H-11097

## DESCRIPTIVE REPORT

*General Locality* ..... Kasaan Bay

*Sublocality* ..... Grindall Island to Kasaan Peninsula

Portion of chart 17426 compared to survey H-11097 soundings and contours

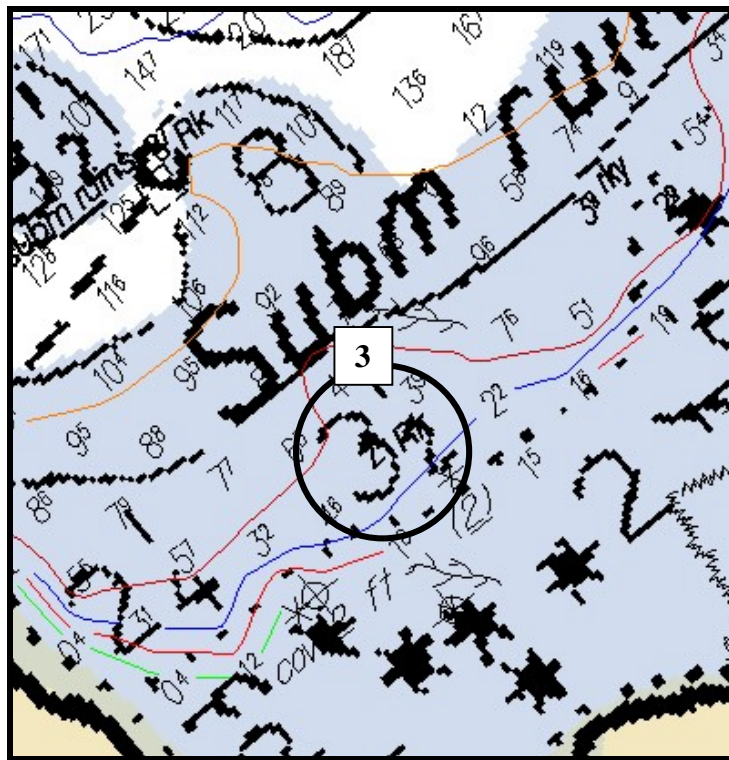
Based on the results of survey H-11097, the Hydrographer recommends correcting the 5-fathom curve label at 55°28'27"N and 132°08'44"W and adding the rky(rocky) symbol in this area.<sup>33</sup> Also, a Rk(rock) symbol should be added at 55°28'23"N and 132°08'42"W.<sup>34</sup>

<sup>34</sup> Concur with clarification. Chart 1 fathom *Rk* at smooth sheet position.

*Portion of chart 17426 compared to survey H-11097 soundings and contours*

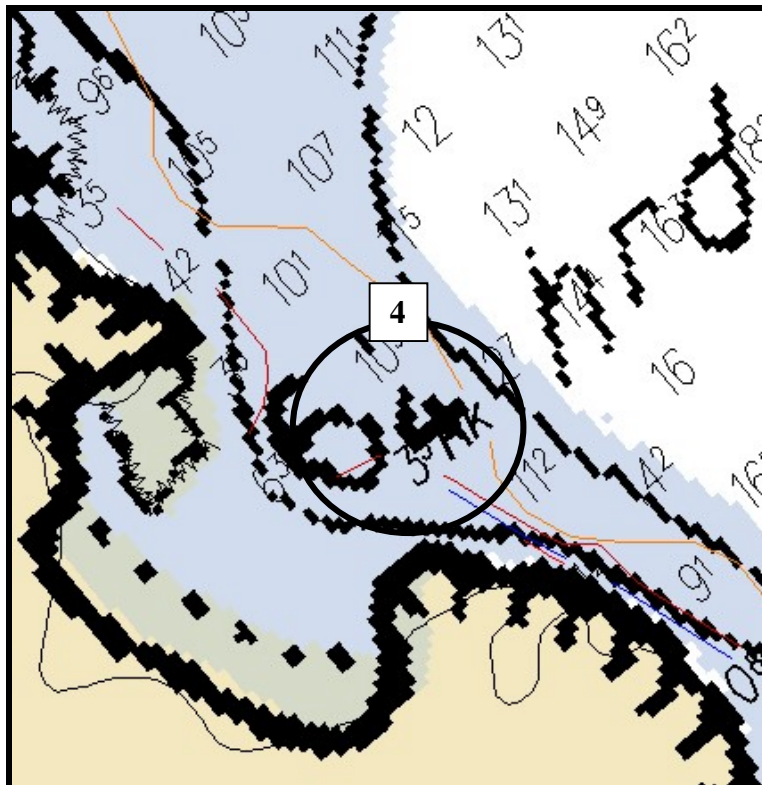
Vicinity	Comment	Location Index
<p><b>Area 3</b> 55°28'35"N and 132°09'19"W</p>	<p>A 2.4 fathom rock sounding in the same position as a charted 3 ½ fathom sounding.</p>	<p>A-4</p>

Based on the results of survey H-11097, the Hydrographer recommends adding a Rk (rock) symbol and changing the sounding value to 2 ½ on the chart at 55°28'35"N and 132°09'19"W<sup>35</sup>

<sup>35</sup> Concur with clarification. Chart 2 fathom, 2 foot *Rk* at smooth sheet position.

Portion of chart 17426 compared to survey H-11097 soundings and contours

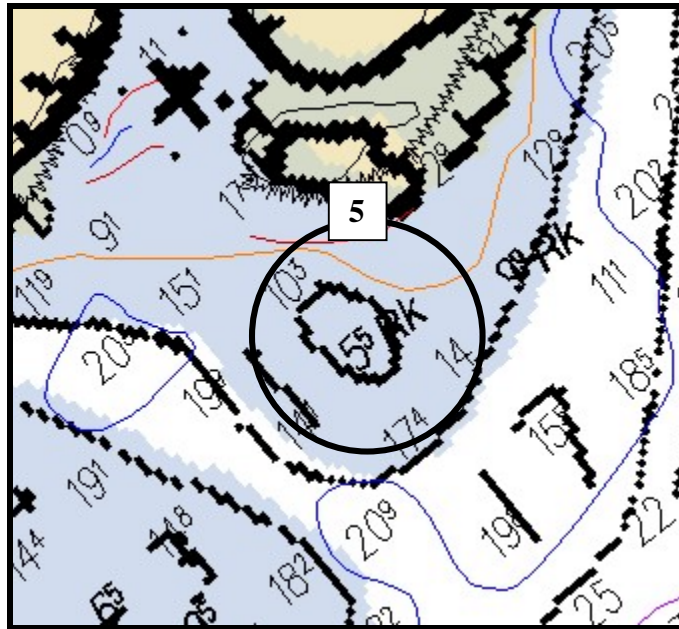
Vicinity	Comment	Location Index
<p><b>Area 4</b> 55°27'32"N and 132°08'36"W</p>	<p>A 3.5 fathom rock sounding in the same position as a charted 6 ¼ fathom sounding.</p>	<p>A-3</p>

Based on the results of survey H-11097, the Hydrographer recommends adding a Rk(rock) symbol and changing the sounding value to 3 ½ on the chart at 55°27'32"N and 132°08'36"W.<sup>36</sup>

<sup>36</sup> Concur with clarification. Chart 3 fathom, 3 foot *Rk* at smooth sheet position.

*Portion of chart 17426 compared to survey H-11097 soundings and contours*

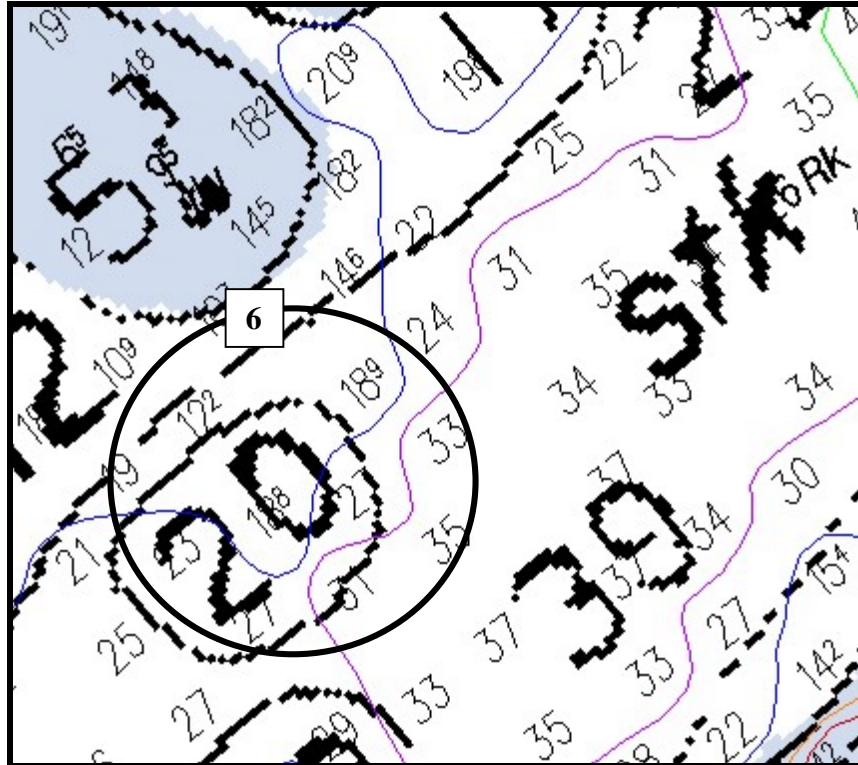
Vicinity	Comment	Location Index
<p><b>Area 5</b> 55°27'17"N and 132°08'41"W</p>	<p>A 5.5 fathom rock sounding in the same position as a charted 10 fathom sounding.</p>	<p>A-3</p>

Based on the results of survey H-11097, the Hydrographer recommends adding a Rk(rock) symbol and changing the sounding value to 5 ½ on the chart at 55°27'17"N and 132°08'41"W. <sup>37</sup>

<sup>37</sup> Concur with clarification. Chart 5 fathom, 3 foot *Rk* at smooth sheet position.

Portion of chart 17426 compared to survey H-11097 soundings and contours

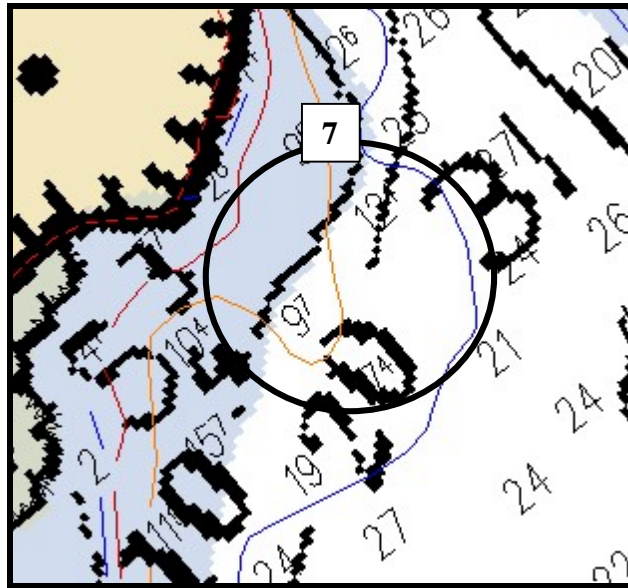
Vicinity	Comment	Location Index
<p><b>Area 6</b> 55°27'11"N and 132°08'54"W</p>	<p>A 12.2 fathom sounding on the seaward side of the 20-fathom curve. The curve is advancing 70 meters seaward in this area.</p>	<p>A-6</p>

Based on the results of survey H-11097, the Hydrographer recommends adjusting the 20-fathom contour line seaward at 55°27'11"N and 132°08'54"W.<sup>38</sup>

<sup>38</sup> Concur. Chart this area based on smooth sheet information.

*Portion of chart 17426 compared to survey H-11097 soundings and contours*

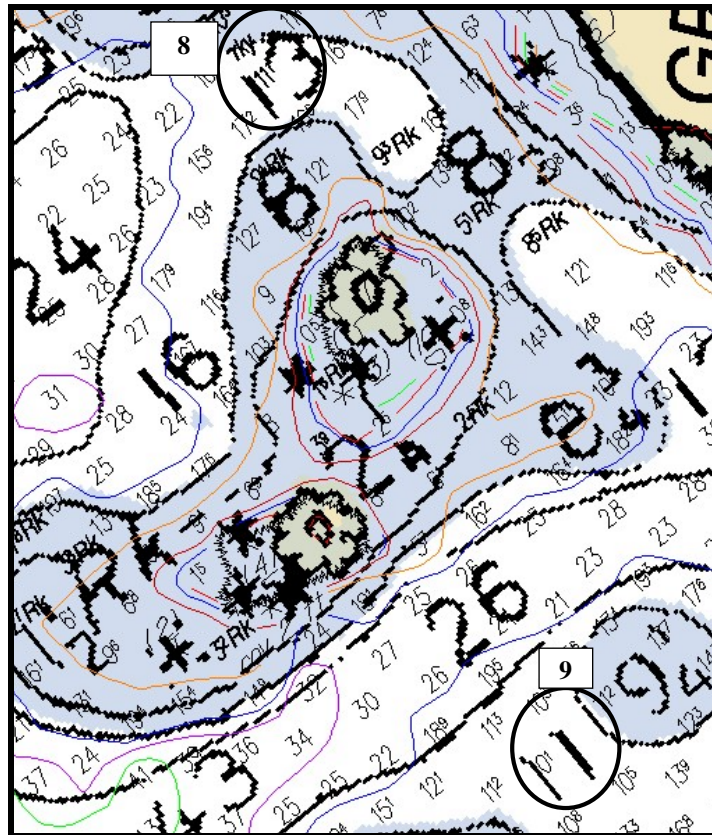
Vicinity	Comment	Location Index
<p><b>Area 7</b> 55°27'01"N and 132°09'24"W</p>	<p>A 9.7 fathom sounding on the seaward side of the 10 fathom charted curve. The 10 fathom curve is approaching the 20 fathom charted curve in this area.</p>	<p>A-2 A-6</p>

Based on the results of survey H-11097, the Hydrographer recommends adjusting the 10-fathom and 20-fathom contour lines seaward at 55°27'01"N and 132°09'24"W.<sup>39</sup>

<sup>39</sup> Concur. Chart this area based on smooth sheet information.

Portion of chart 17426 compared to survey H-11097 soundings and contours

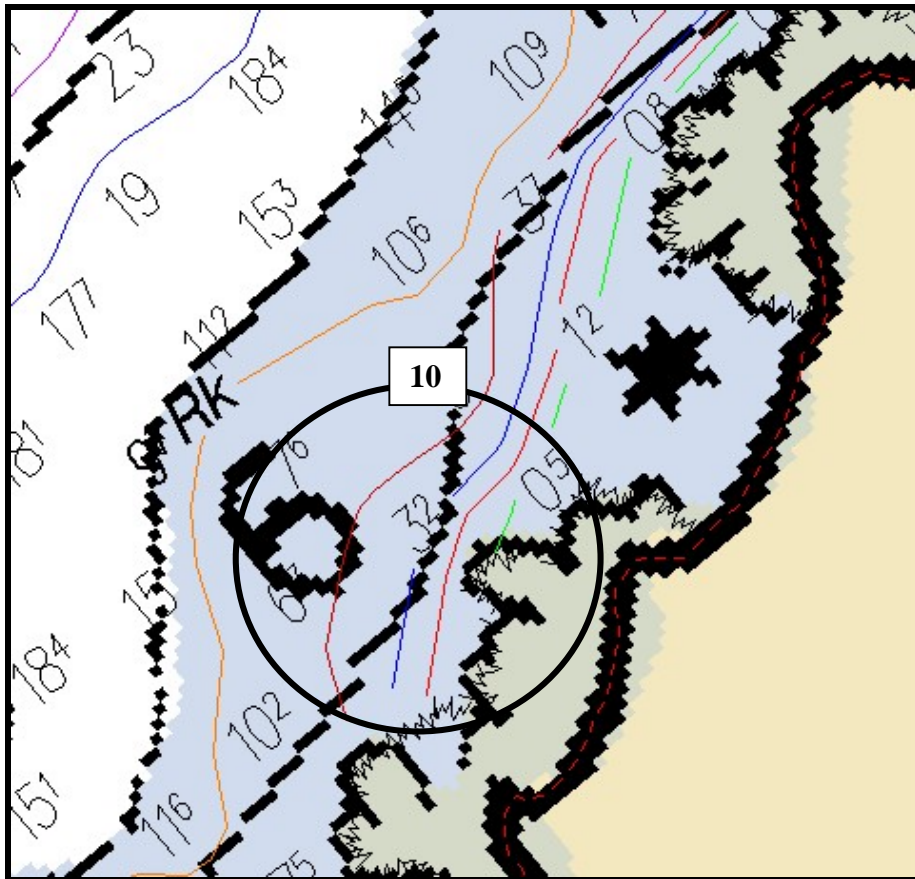
Vicinity	Comment	Location Index
<b>Area 8</b> 55°26'46"N and 132°09'04"W	A 11 fathom sounding in the same position as a charted 13 fathom sounding.	A-6
<b>Area 9</b> 55°26'25"N and 132°09'18"W	A 10.1 fathom sounding in the same position as a charted 11 fathom sounding.	A-6

Based on the results of survey H-11097, the Hydrographer recommends changing the charted 13 fathom sounding to an 11.1 fathom sounding at 55°26'46"N and 132°09'04"W, and changing the charted 11 fathom sounding to a 10.1 fathom sounding at 55°26'25"N and 132°09'18"W.<sup>40</sup>

<sup>40</sup> Concur with clarification. Chart these areas based on smooth sheet information.

Portion of chart 17426 compared to survey H-11097 soundings and contours

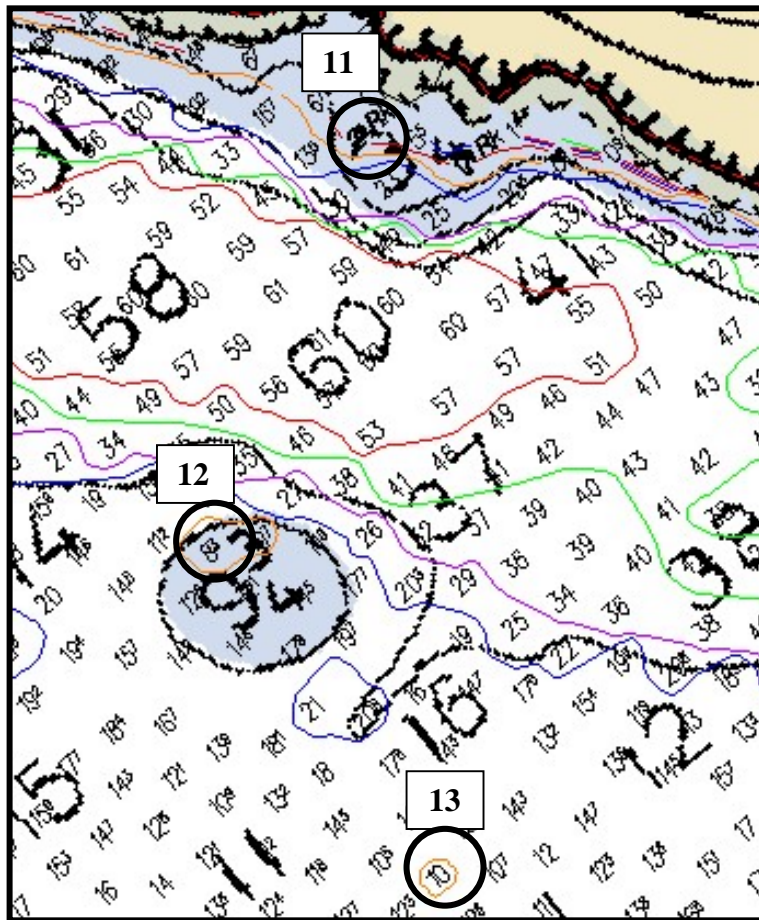
Vicinity	Comment	Location Index
<p><b>Area 10</b> 55°26'50"N and 132°07'21"W</p>	<p>A 3.2 fathom sounding seaward of the charted 5 fathom curve. The surveyed curve is advancing seaward 30 meters in this area.</p>	<p>A-7</p>

Based on the results of survey H-11097, the Hydrographer recommends adjusting the 5 fathom curve seaward 30 meters at 55°26'50"N and 132°07'21"W.<sup>41</sup>

<sup>41</sup> Concur. Chart this area based on smooth sheet information.

Portion of chart 17426 compared to survey H-11097 soundings and contours

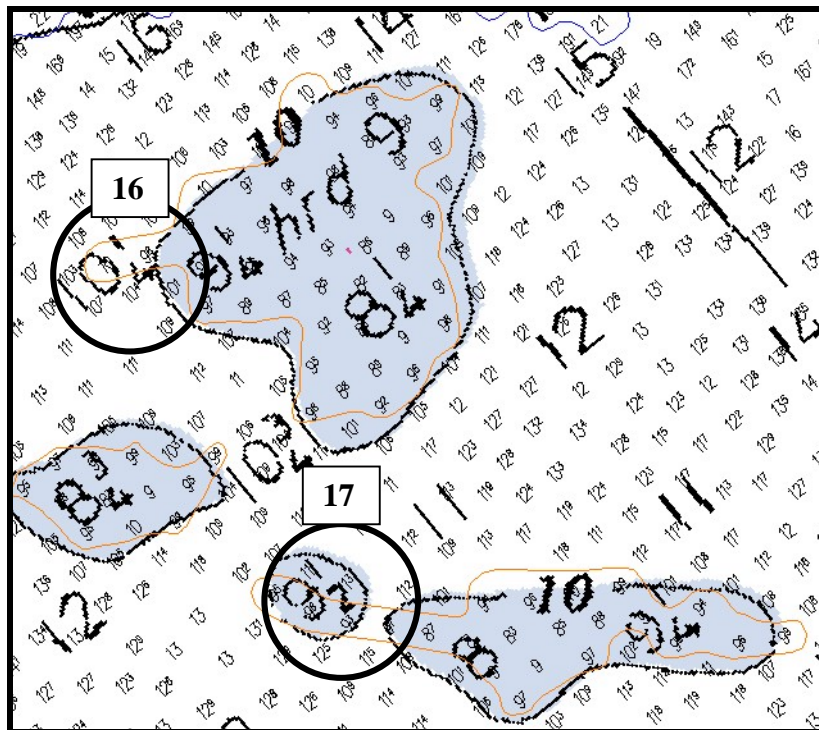
Vicinity	Comment	Location Index
<b>Area 14</b> 55°27'28"N and 132°11'07"W	A 2.6 fathom sounding near a charted 3 ¾ fathom sounding.	A-2
<b>Area 15</b> 55°27'32"N and 132°11'16"W	A 8.4 fathom rock sounding on the charted 10 fathom curve.	A-2

Based on the results of survey H-11097, the Hydrographer recommends changing the 3 ¾ Fathom sounding to a 2 ½ fathom sounding at 55°27'28"N and 132°11'07"W<sup>45</sup> and adding a Rk(rock) symbol with a 8.4 fathom sounding at 55°27'32"N and 132°11'16"W.<sup>46</sup>

<sup>46</sup> Concur with clarification. Chart 8 fathom 2 foot *Rk* at smooth sheet position.

Portion of chart 17426 compared to survey H-11097 soundings and contours

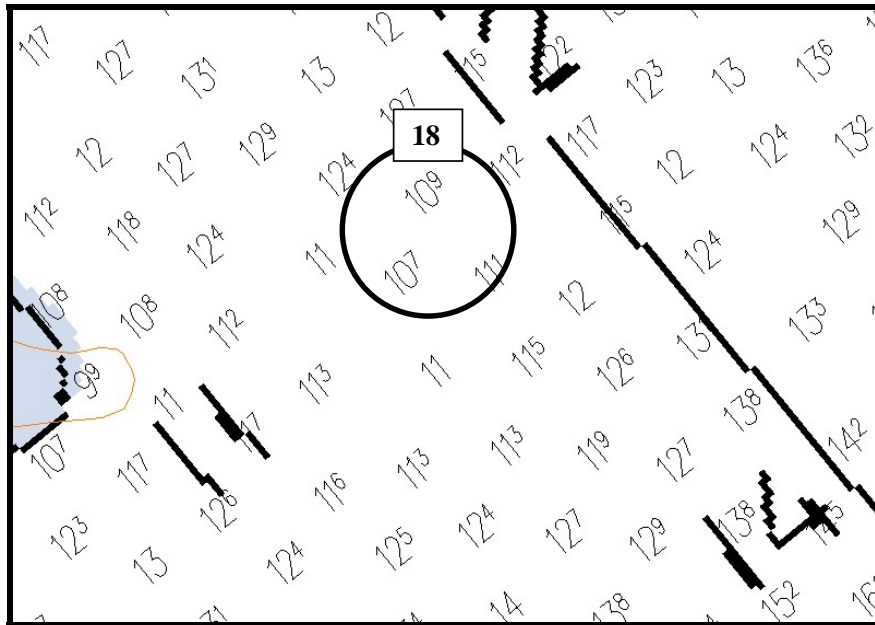
Vicinity	Comment	Location Index
<p><b>Area 16</b> 55°26'27"N and 132°10'36"W</p>	<p>A 10 fathom sounding at the same location as a charted 10 ¼ fathom sounding. The surveyed sounding extends the 10 fathom curve to the North West 90 meters.</p>	<p>A-8</p>
<p><b>Area 17</b> 55°26'08"N and 132°10'38"W</p>	<p>A 9.1 fathom sounding on the charted 10 fathom curve. The surveyed sounding connects to a charted 10 fathom curve to the North West, removing a channel.</p>	<p>A-8</p>

Based on the results of survey H-11097, the Hydrographer recommends adjust the 10 fathom curve to encompass the 10 fathom sounding at 55°26'27"N and 132°10'36"W, and adjusting the 10 fathom curve to encompass the 9.1 fathom sounding at 55°26'08"N and 132°10'38"W. The latter adjustment should combine two separate smaller curves into one larger curve.<sup>47</sup>

<sup>47</sup> Concur. Chart this area based on smooth sheet information.

*Portion of chart 17426 compared to survey H-11097 soundings and contours*

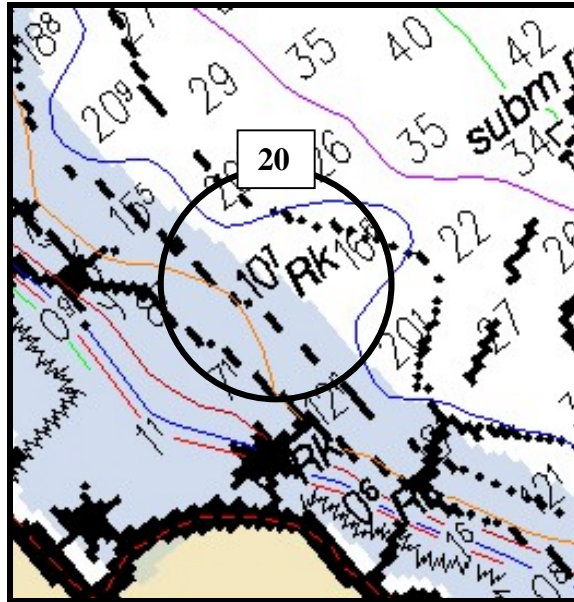
Vicinity	Comment	Location Index
<p><b>Area 19</b> 55°28'43"N and 132°08'05"W</p>	<p>The ten fathom curve is advancing. In addition the charted 10 fathom curve surrounding a 9 ¼ fathom sounding appears incorrect.</p>	<p>A-4</p>

Based on the results of survey H-11097, the Hydrographer recommends removing the 9 ¼ fathom sounding and it’s surrounding 10 fathom curve and adjusting the 10 fathom curve around Streets Island at 55°28’43”N and 132°08’05”W.<sup>49</sup>

<sup>49</sup> Concur with clarification. Chart 8 fathom 5 foot sounding at smooth sheet position.

*AWOIS item 52760, 2002 bathymetry and 2002 search position; Chart 17426*

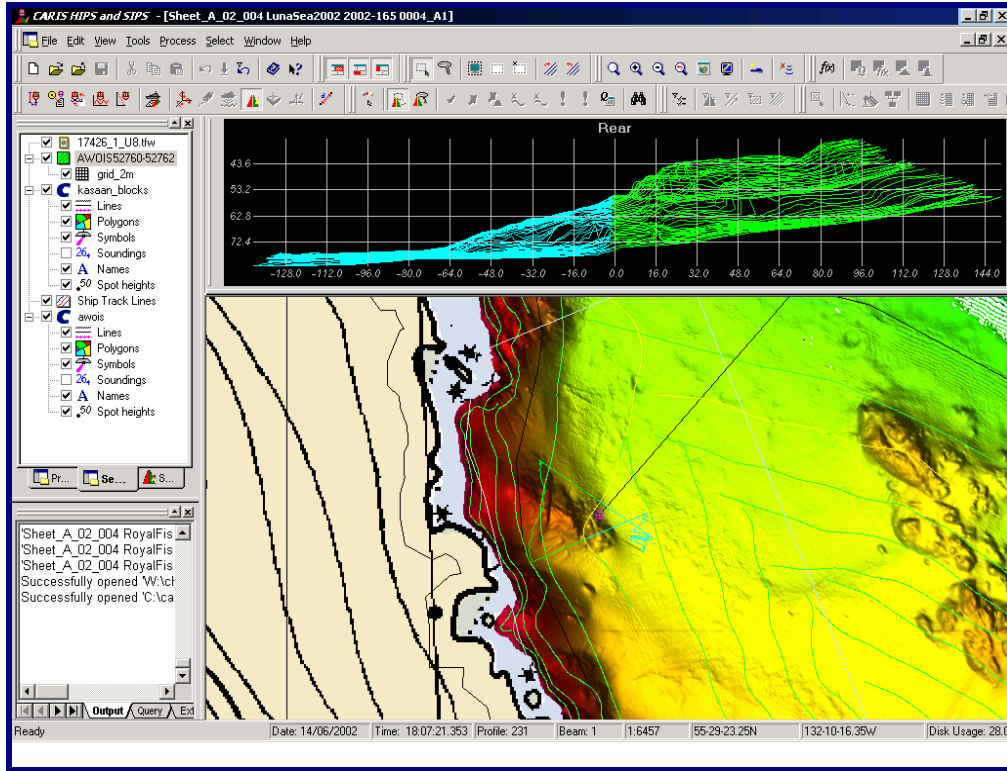
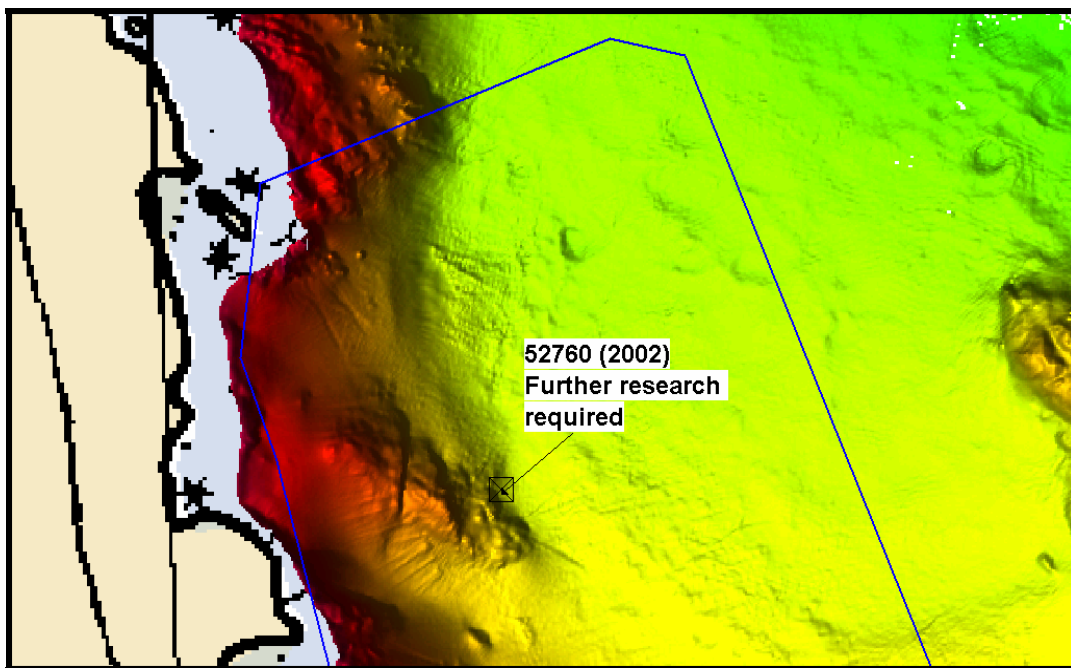
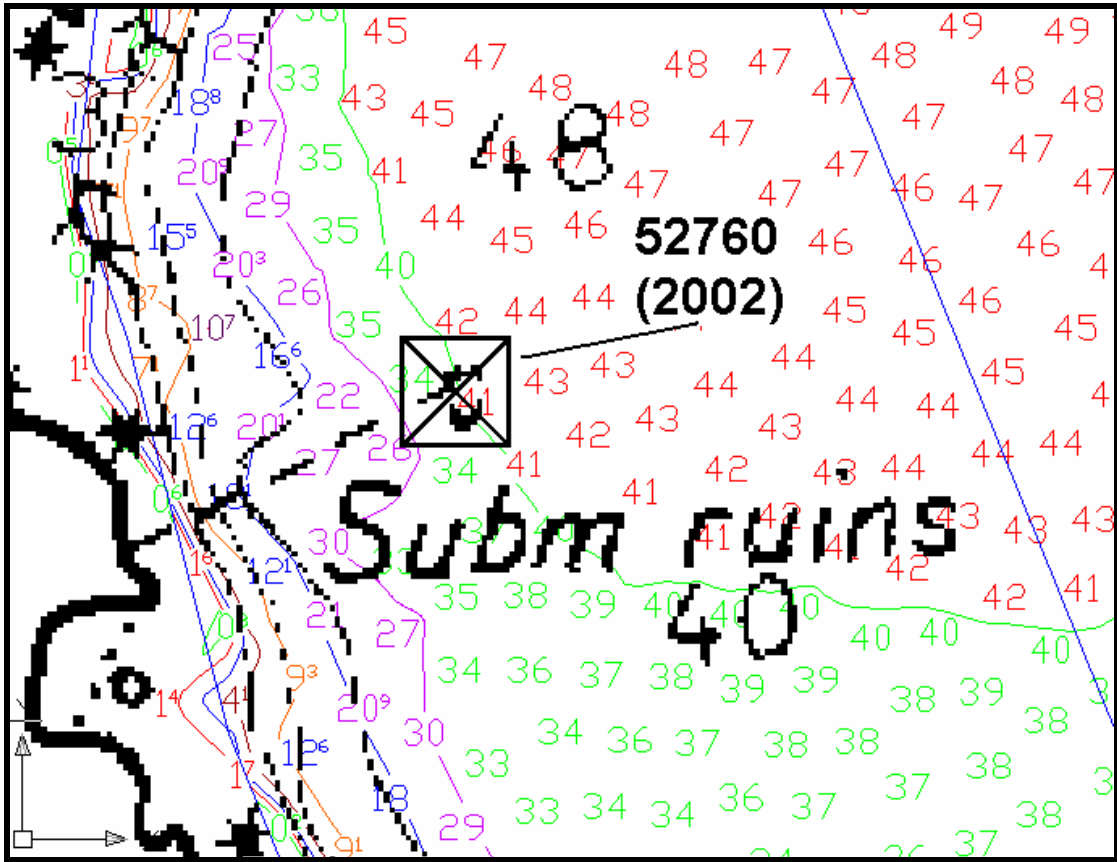
Investigation Summary: The search area has 200% SWMB coverage. A review of the digital terrain model detected some topographic relief. A review of the bottom profile in CARIS did not show any obvious evidence of ruins. Further investigation with divers or SS sonar would be required to determine if these ruins still exist.

Based on the results of survey H-11097, the hydrographer recommends retention of the submerged ruin symbol until further investigation disproves its presence.<sup>51</sup>

Proprietary Evaluator comment: The hydrographer found no conclusive evidence of ruins, and PHB review of the data showed no evidence of the ruins. Smooth sheet portrayal of the ruins originated from the chart, not the survey. The evaluator recommends removing submerged ruins symbol and notation from all affected charts. Chart the area according to survey H11097.

<sup>51</sup> Do not concur. The ruins symbol portrayed on the smooth sheet originated from the chart and is not source information from the present survey. The ruins are not evident in the DTM or smooth sheet. The evaluator recommends removing the charted ruins symbols and *subm ruins* notation. See AWOIS report attached to this report.
